Subject: Rice Solar Energy Project (09-AFC-10)  
Response to CEC Workshop Queries 9 and 10

**Response to CEC Staff Workshop Queries 9 and 10**

**Rice Solar Energy Project**

(09-AFC-10)

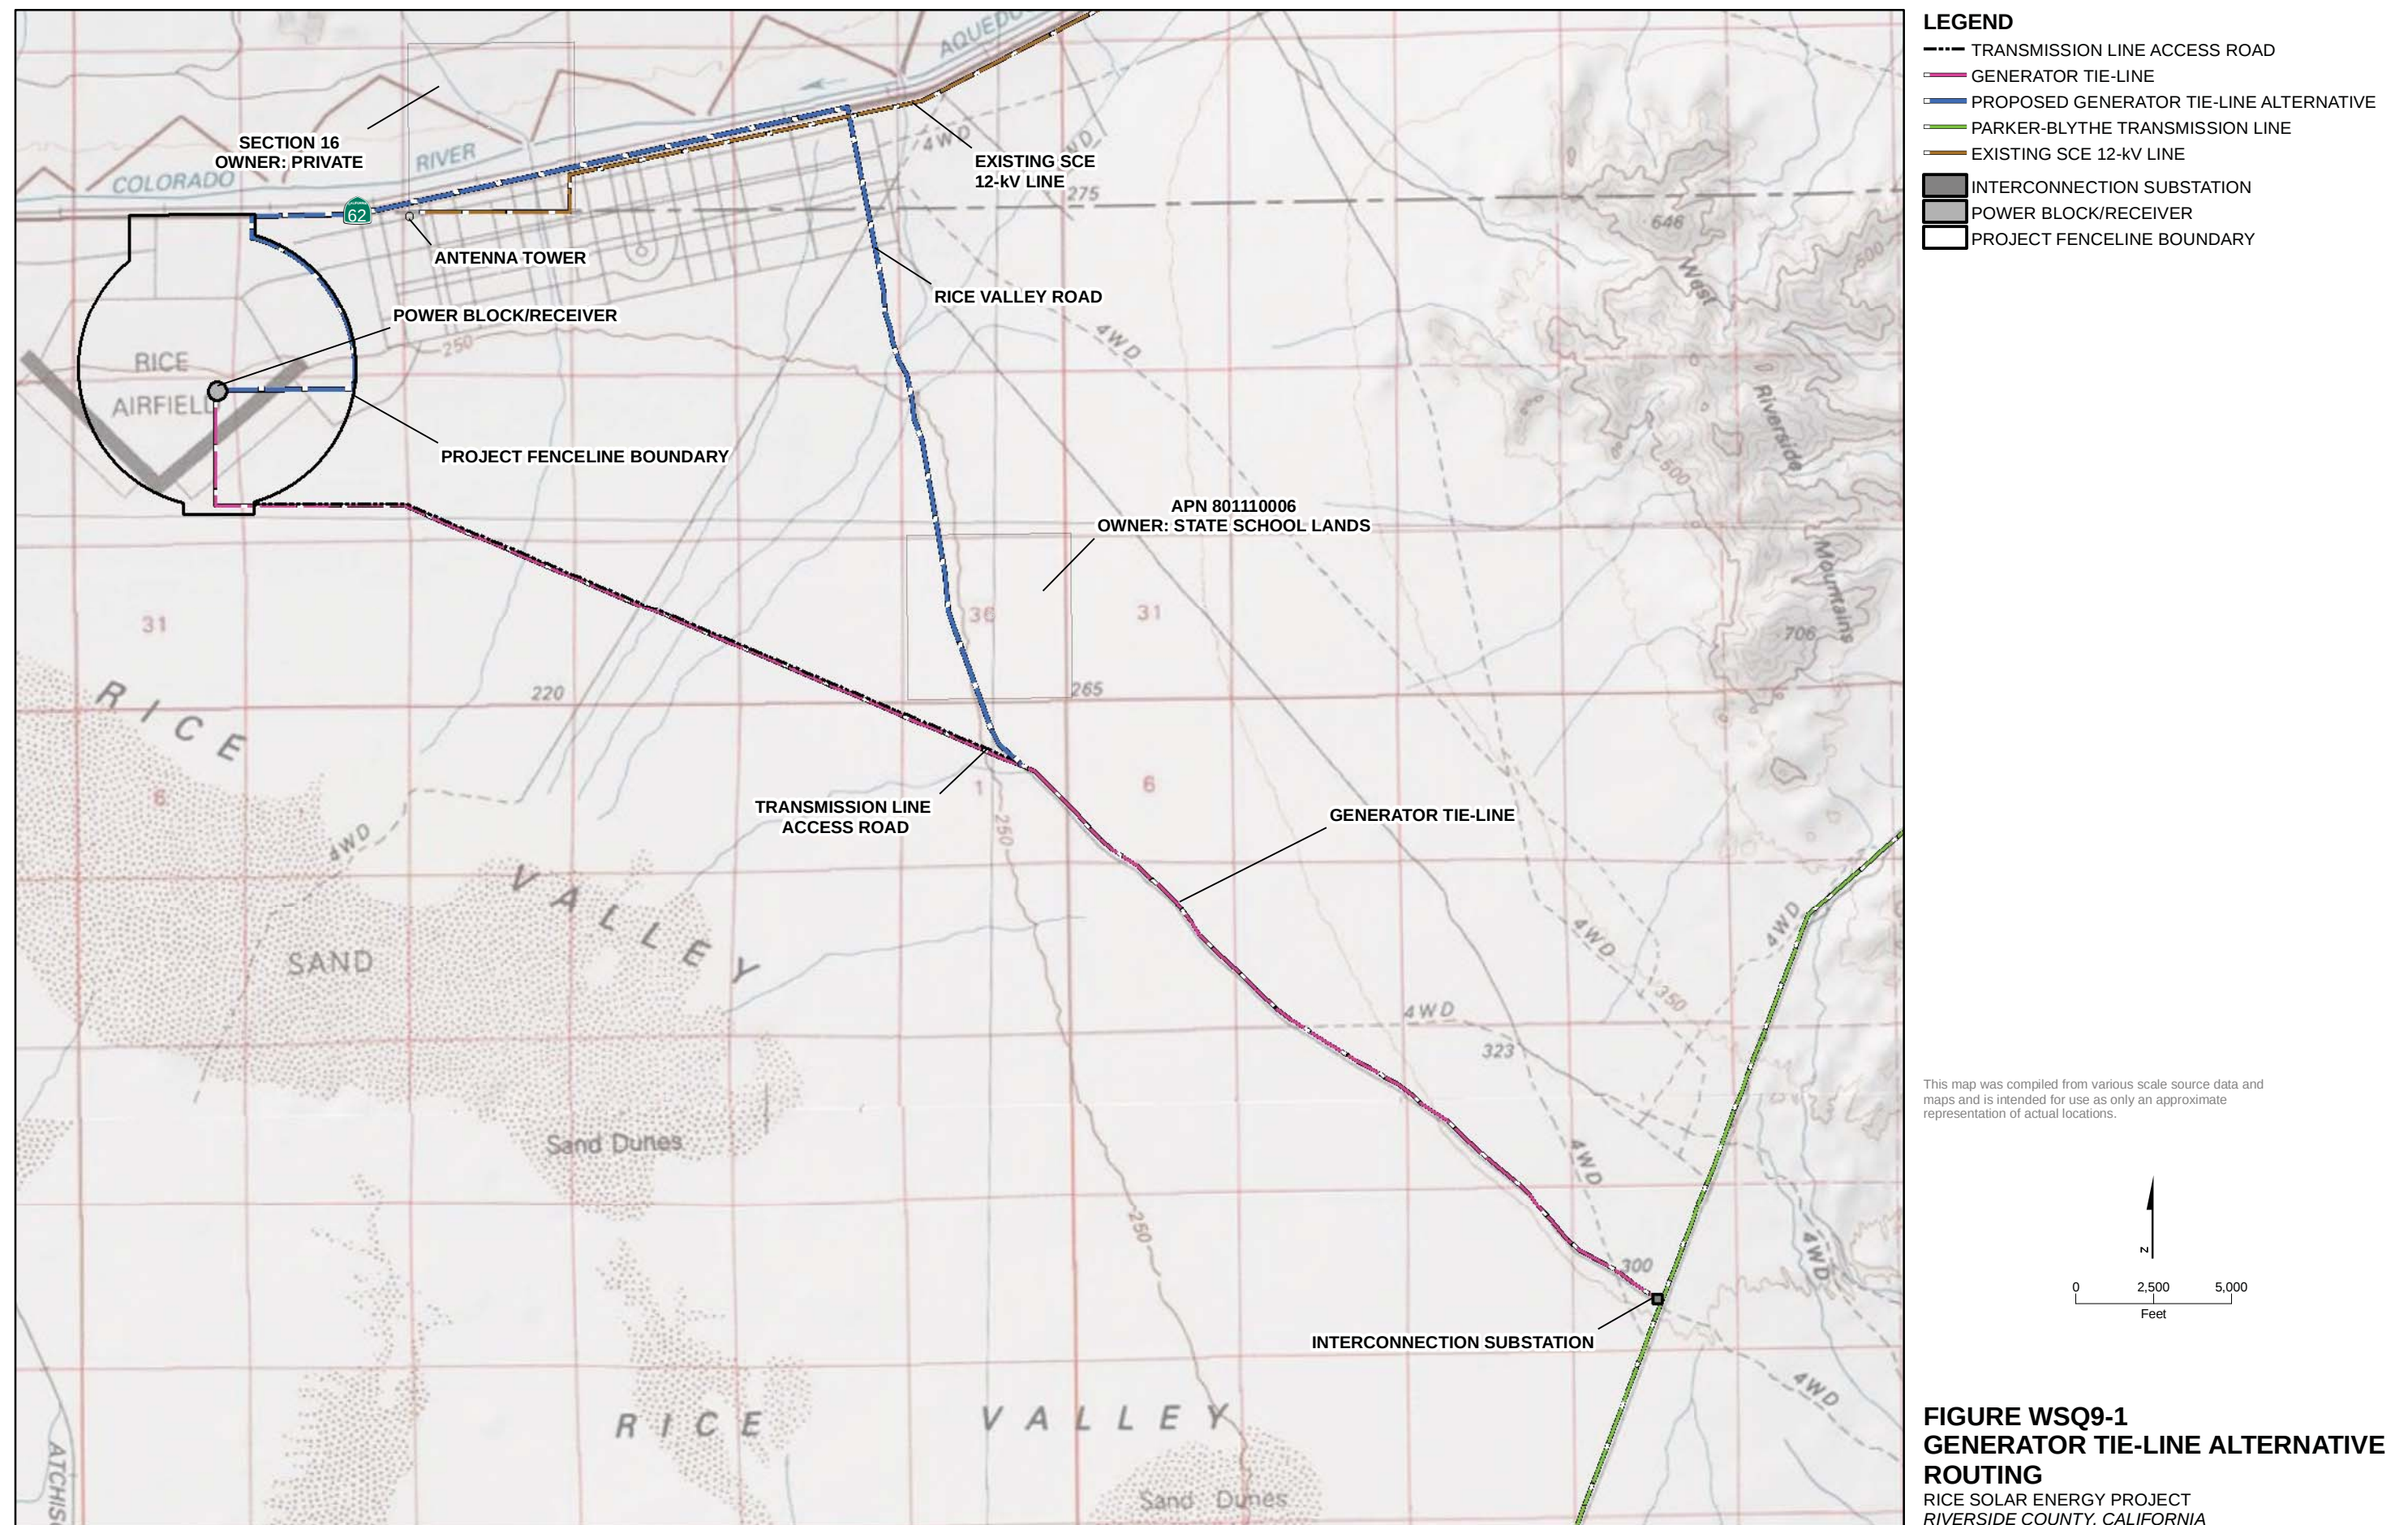
WSQ 9      *Please provide a discussion of the environmental and engineering implications of a generator tie-line alternative routing that would follow only existing roadways, between the RSEP site and Rice Valley Road.*

An alternate to the proposed route that would follow existing roadways and would not require construction of an access road is shown on Figure WSQ9-1. This alternate would exit the power block directly to the east and follow a proposed access road within the heliostat field. The tie-line would then turn north inside the RSEP property boundary and run along the RSEP's circular perimeter road to the north and northwest. At the north end of the heliostat field, the route would traverse the construction laydown area on previously disturbed land over a distance of approximately 500 feet to the southern side of State Route (SR) 62. From here, the route would turn at a right angle to the east and follow SR 62 to Rice Valley Road, a distance of 3.8 miles. The route would then follow the existing Rice Valley Road south for 4.1 miles (starting at the power block) to the point where the proposed routing connects with Rice Valley Road. This new route would therefore require 10.1 miles of new transmission line to cover the same distance that the existing route would cover in approximately 5.7 miles, an addition of approximately 4.4 miles of routing.

The resulting increase in the length of the generator tie line of 40 percent, to 15.4 miles from 11.0 miles (power block to substation), would increase the capital cost of the project approximately \$4.5M (not including any additional costs for easements, land purchase options, BLM land leasing fees, additional environmental permitting studies, etc.). In addition, the project's operational cost would increase because of additional power line losses over the increased length of the conductor.

The 12-kV line does not parallel SR 62 along its entire length, instead making a jog to the south for approximately 1.5 miles. This is likely because the parcel of land encompassing this portion of the line (Section 16) is privately owned (see Figure WSQ9-1). Because it was not possible or feasible for SCE to route its 12-kV line through this private parcel, it also may not be feasible for RSE to route a generator tie-line through it. If this were the case, then the generator tie-line would take the same route as the SCE 12-kV line. This route diverges from SR 62 for more than a mile, however, and could require that RSE construct new access road in this routing because there is not an adequate existing access road that accompanies this line.

**Environmental Factors** – Constructing the alternative generator tie-line along SR 62 to Rice Valley Road would require construction within and along the margins of the World War II Desert Training Center site known as Camp Rice. Camp Rice has been found by the BLM to be eligible for listing in the National Register of Historic Places. Although the tie-line would cause only a small amount of direct physical disturbance to this historic site, it would alter the setting. This effect would occur across the length and width of Camp Rice. If the generator tie-line were required to parallel or replace the existing SCE 12-kV line where the SCE line is routed south to avoid private property, then the new line would run through the Camp Rice site, instead of along the margins of it, for a greater distance.

**FIGURE WSQ10-1**  
Field Sizes Comparison

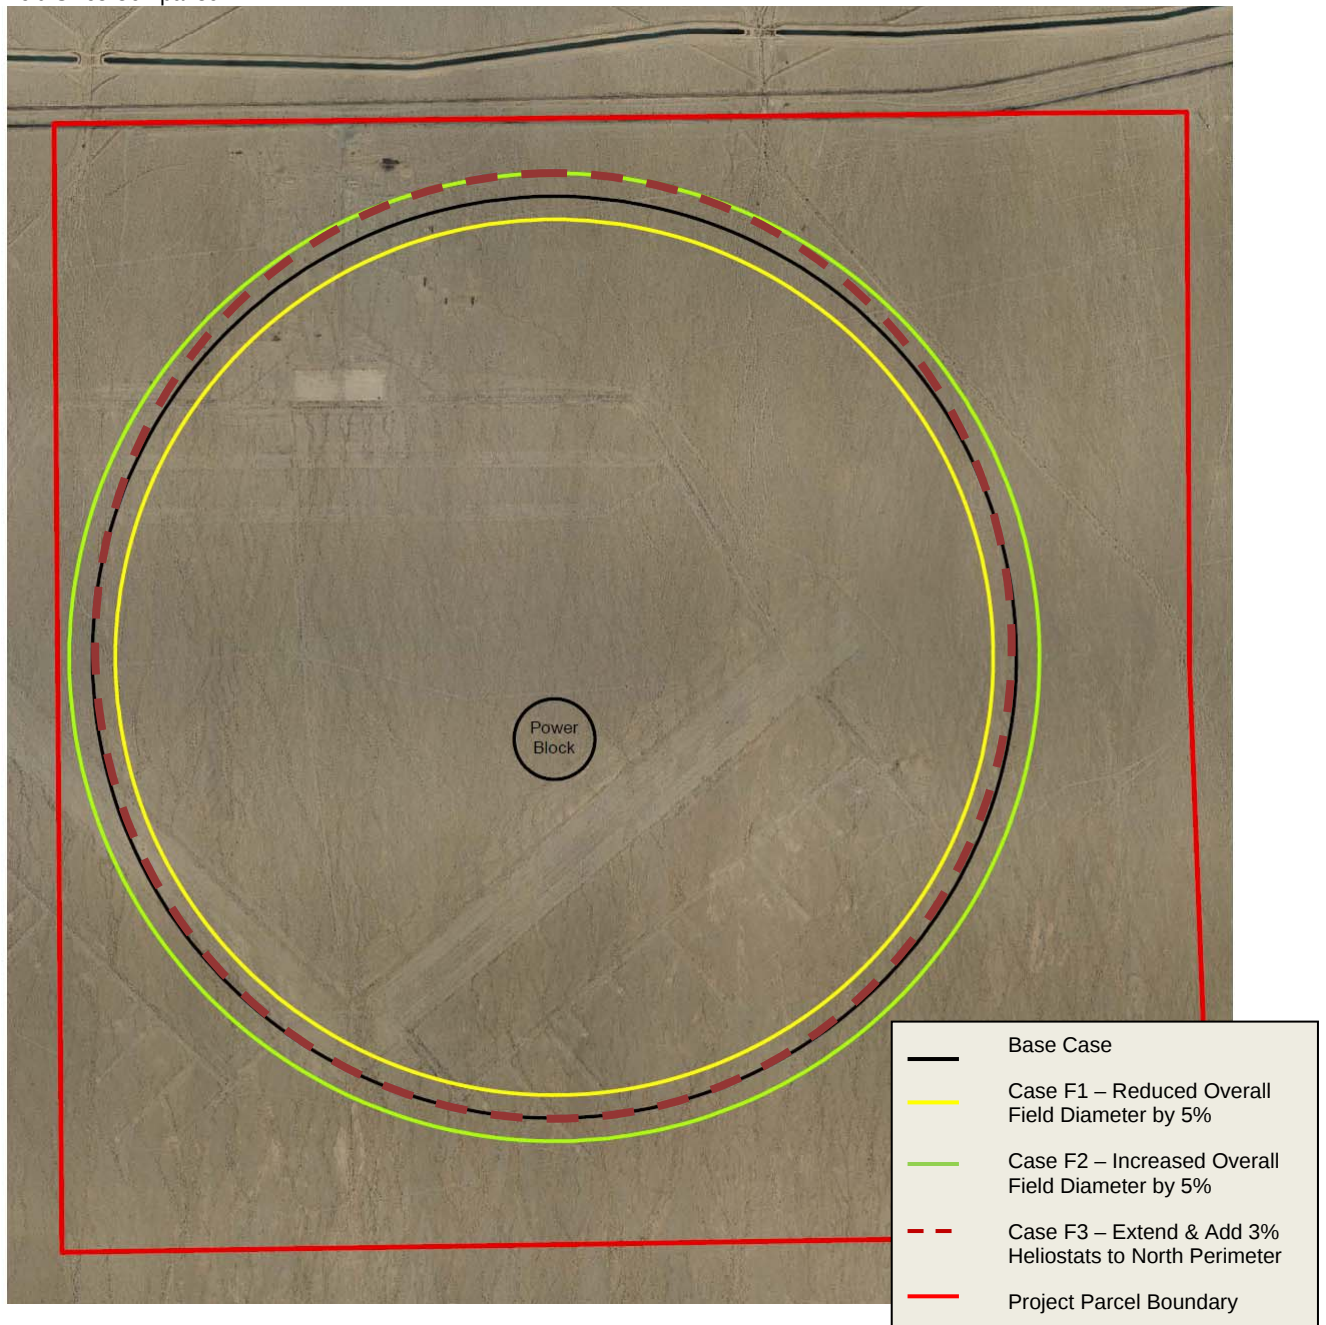
WSQ 10 *Please provide a discussion of the effects on project efficiency and the environment, of an alternative project configuration that would feature a smaller heliostat field size.*

In Cases F1 and F2, the maximum distance from the tower to field boundary was changed by  $\pm 5$  percent while maintaining the same number of heliostats. Reducing the distance from the tower to the outer boundary in this case has the effect of packing the heliostats more densely. Conversely, when the heliostat field diameter is increased, the heliostats are less densely packed. As shown in Table WSQ10-1, the annual power output would be lower under both of these cases. Additionally, the first year PPA prices would increase by 2.5 percent under both alternatives. Either configuration would generate less electricity and at a higher cost to the customer.

In Case F3, the heliostat field is increased similarly to Case F2, but only on the north side. As shown in the data summary, additional power output could be achieved without adverse impacts to the unit cost of energy under this scenario. As explained, additional heliostats can enhance project economics when placed effectively. Conversely, a reduced number of heliostats would erode the cost-effectiveness of the facility. Similarly, a less optimally packed heliostat field with the same number of heliostats, as in Case F1, would reduce power output and increase the unit cost of energy. The power output shortfall in these cases would necessarily have to come from a separate project with greater incremental environmental impacts.

Figure WSQ10-1 below illustrates the heliostat field for each of three cases discussed.

The base case, as demonstrated, provides an efficient field configuration designed to function effectively within the previously disturbed project parcel boundary. Although additional power can be achieved with a larger heliostat field, a reduced heliostat field will further burden the economics of the project and create greater incremental environmental impacts from having to make up the shortfall from a supplemental project.
